# TOWN OF CORTLANDT PLANNING BOARD

**MEETING AGENDA.....PLANNING BOARD**  
**TOWN OF CORTLANDT**  
**6:30 TUESDAY EVENING\***  
**OCTOBER 1, 2024**

**PB 2024-1** a. Public Hearing: Application of KPB Properties LLC for Site Development Plan approval and a referral from the Town Board of a Petition for a Zoning Text Amendment for a proposed 4-story, 75,000 sq. ft. self-storage facility located at 3 Locust Avenue. Drawings latest revised September 24, 2024.

PROJECT NAME: **PROPOSED SELF-STORAGE FACILITY**  
3 LOCUST AVENUE  
CORTLANDT MANOR, NY 10567  
COUNTY OF WESTCHESTER  
SECT.: 34.5, BLOCK: 2, LOT: 6

**Floor Plan**  
SCALE: 1/4" = 1'-0"

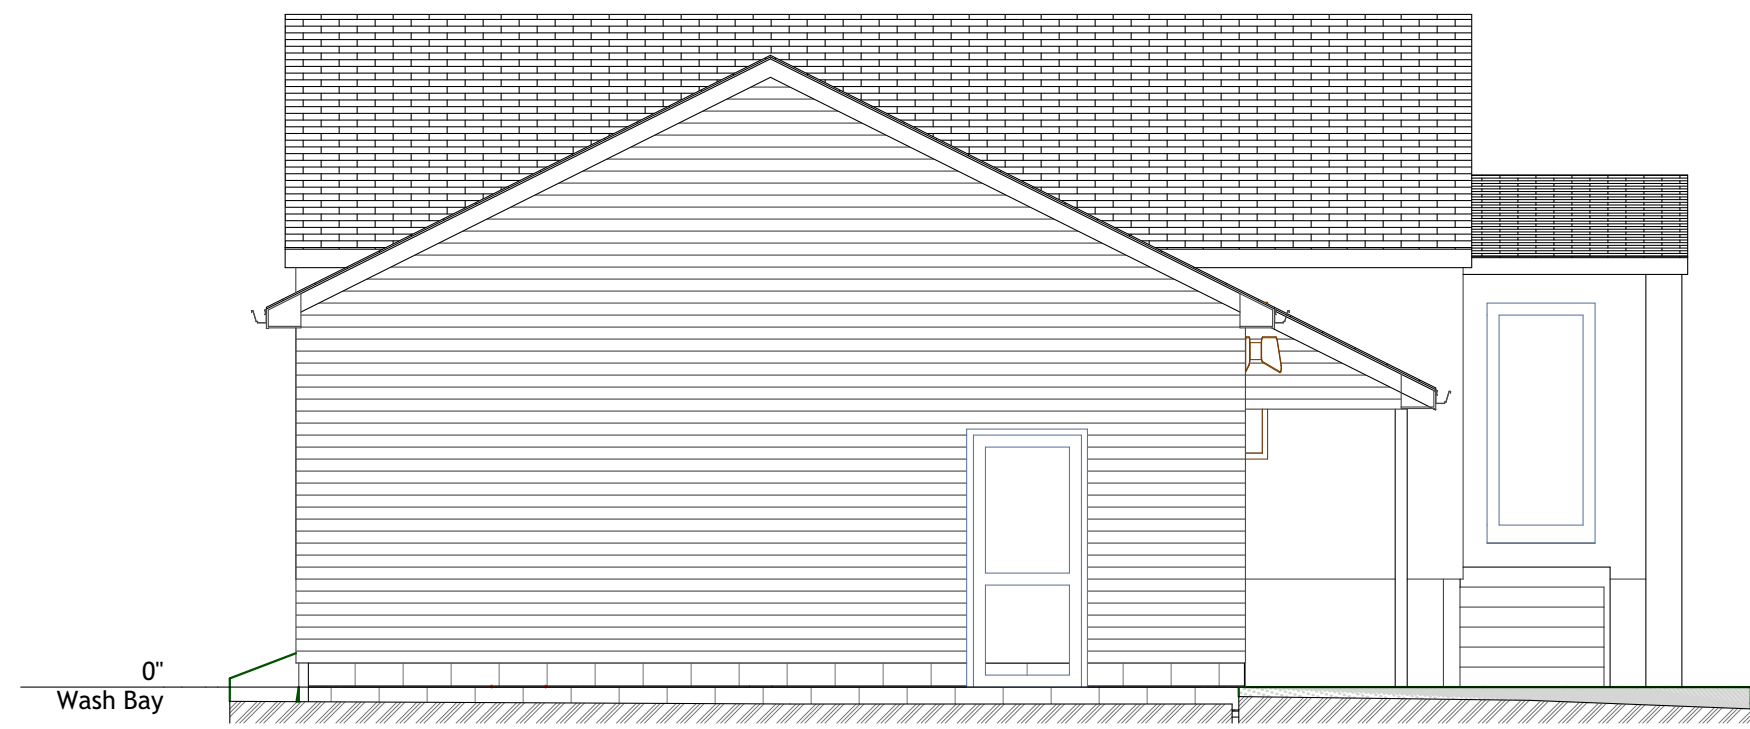
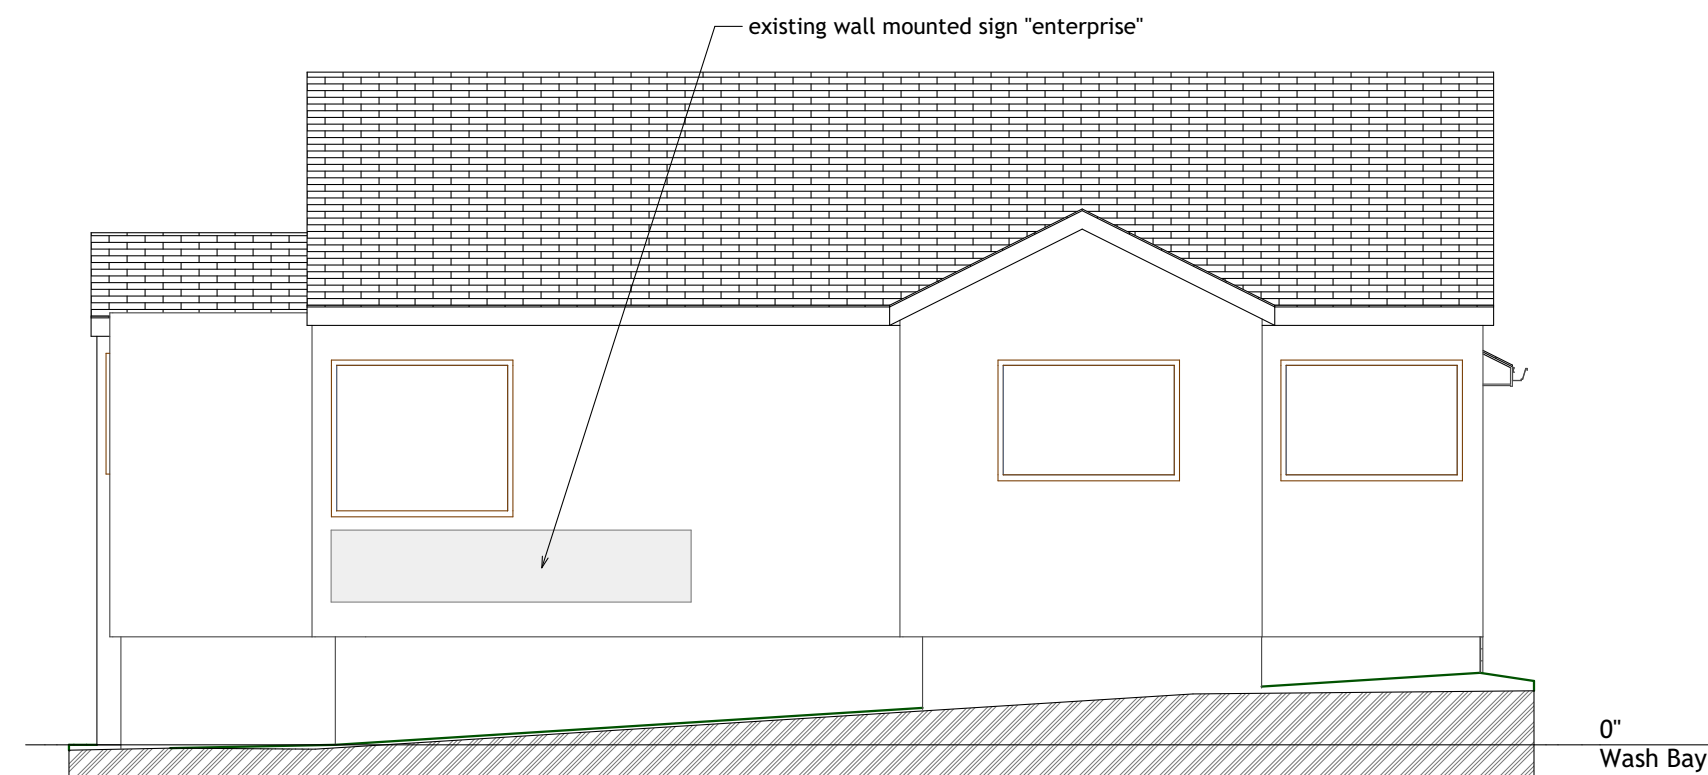
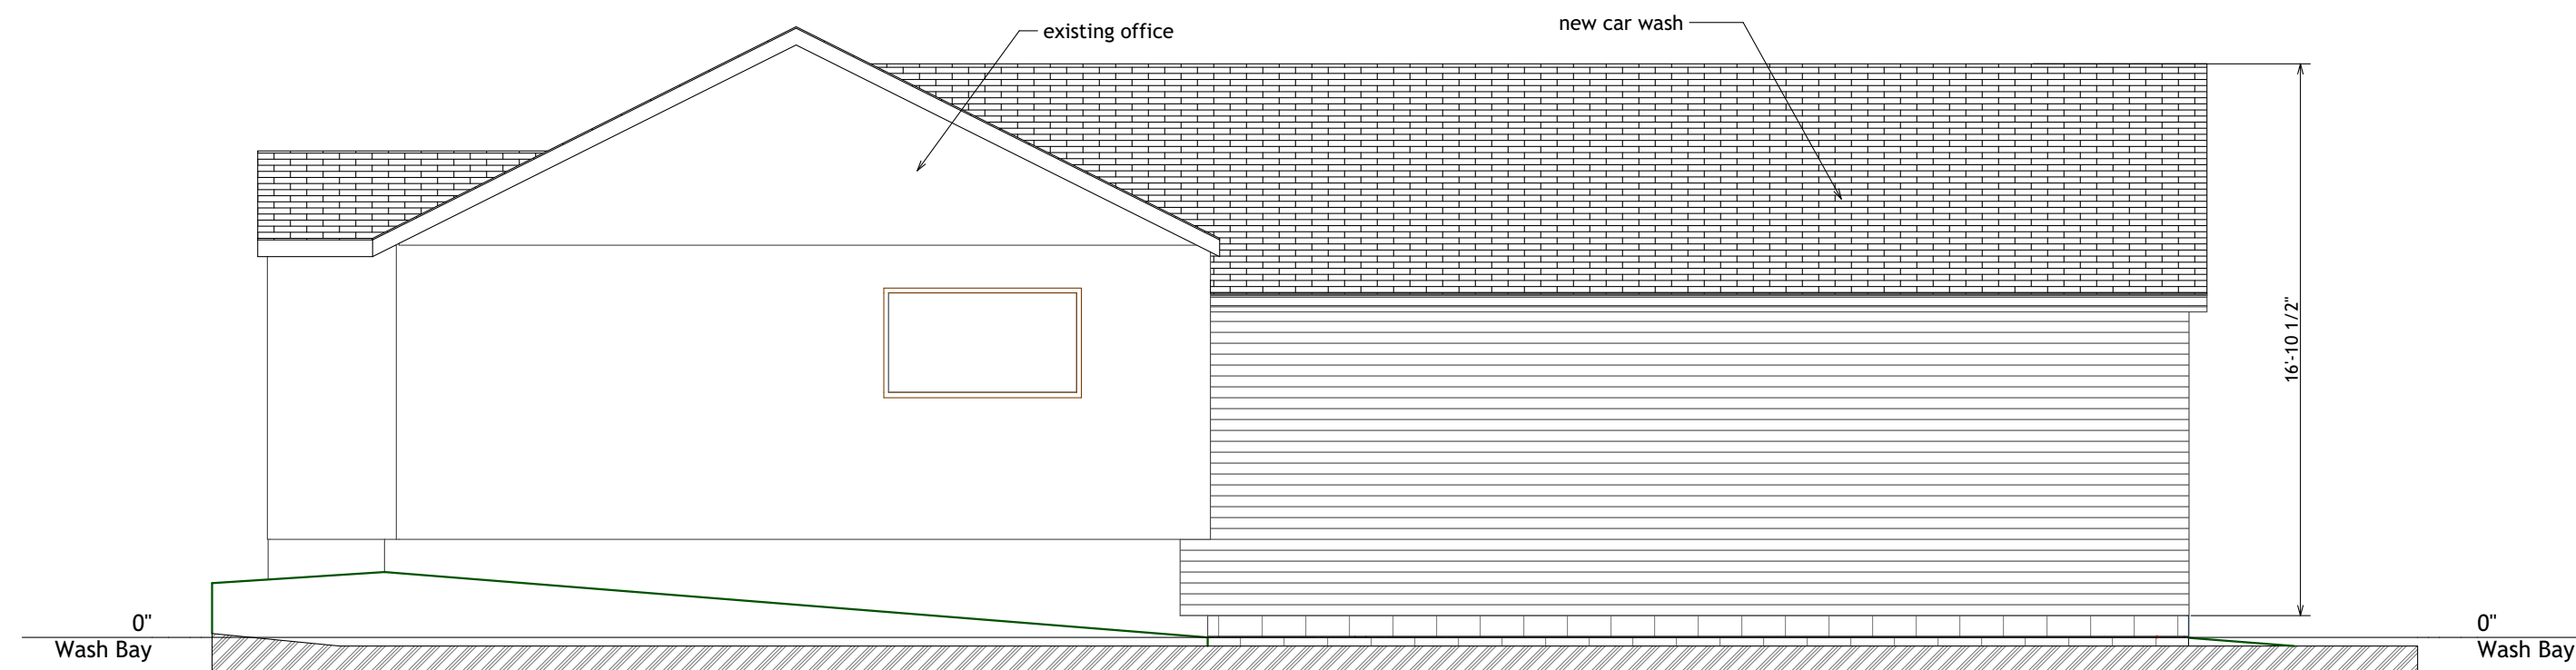
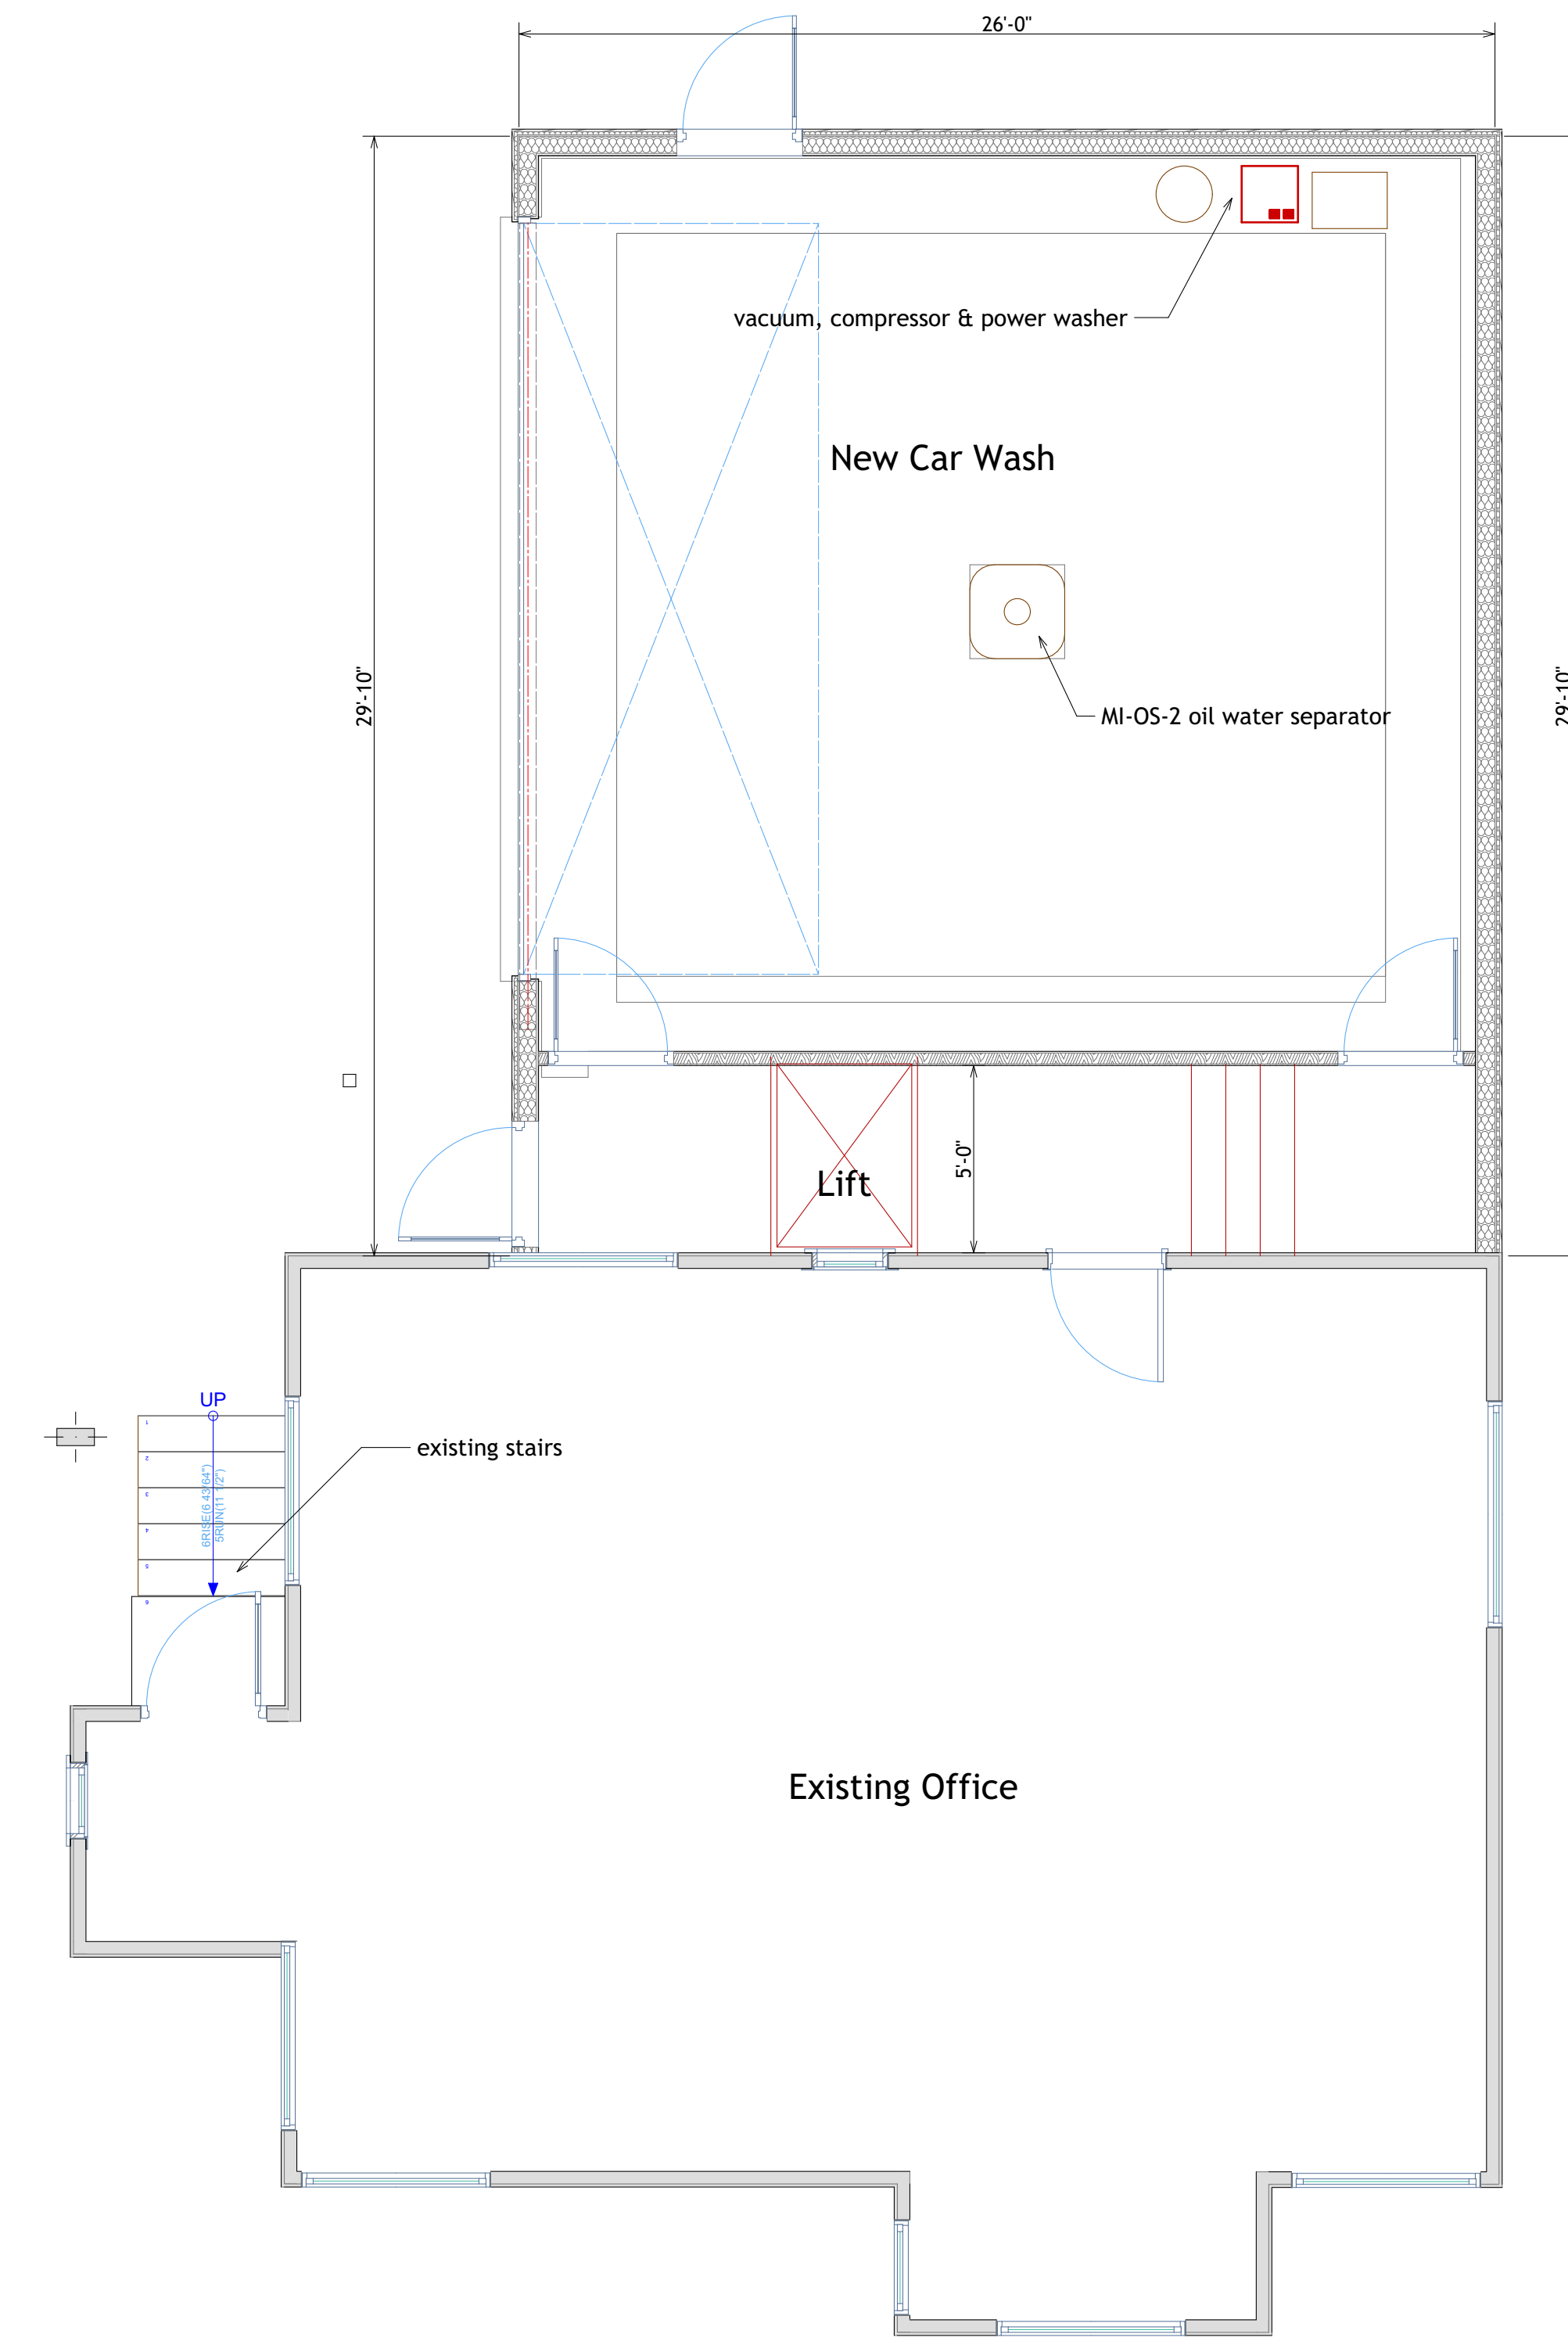
13. Sheet 2 of 2: Provide details, maintenance procedures, and calculations for oil/water separator.
  14. Sheet 2 of 2: Provide noise level emissions to determine the decibels at the property line of the car wash.
